Office Action Summary	Application No.	Applicant(s)	
	10/634,911	MALLETTE ET AL.	
	Examiner	Art Unit	
	Tony H. Winner	3611

DETAILED ACTION

Attachment A

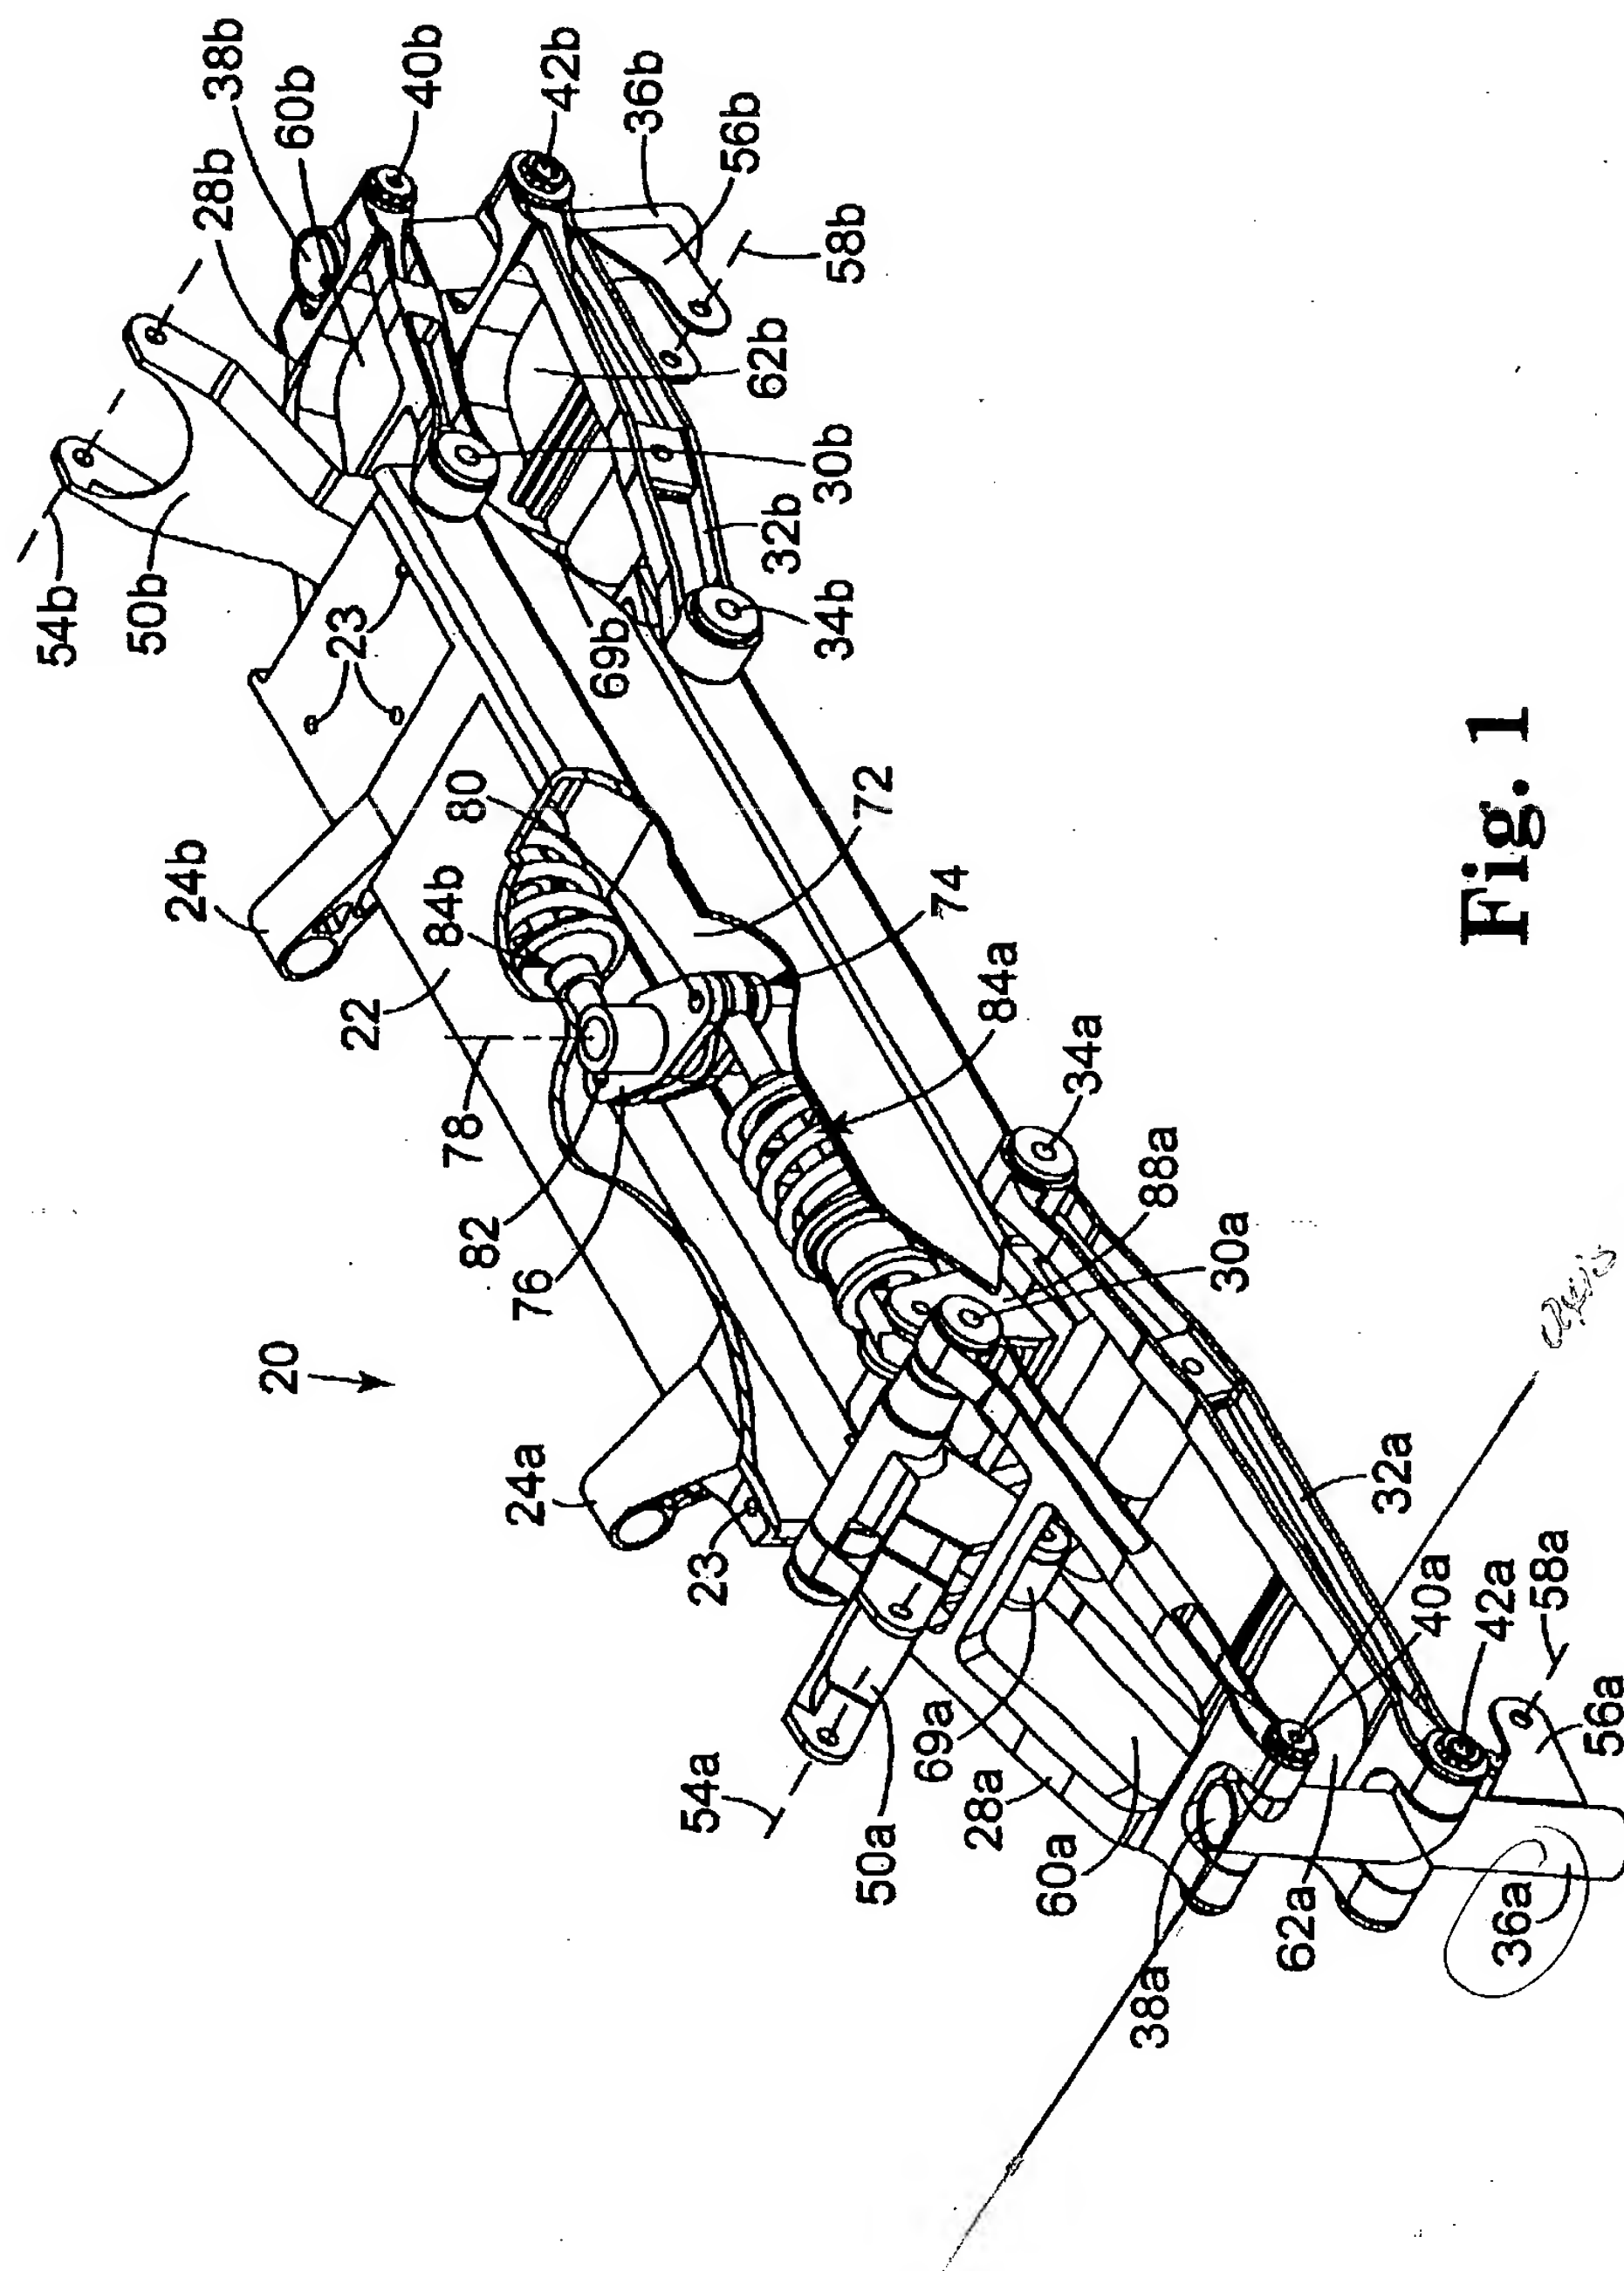
f. (applies to claim 12) an axis of rotation defined by a line which passes through one of first protrusion and second protrusion connected to the suspension element (see attachment A).

Taking position that claim 12 depending on claim 7, Karpik as modified by Nakazawa discloses an axis of rotation defined by a line which passes through one of first protrusion and second protrusion connected to the suspension element (see attachment A).
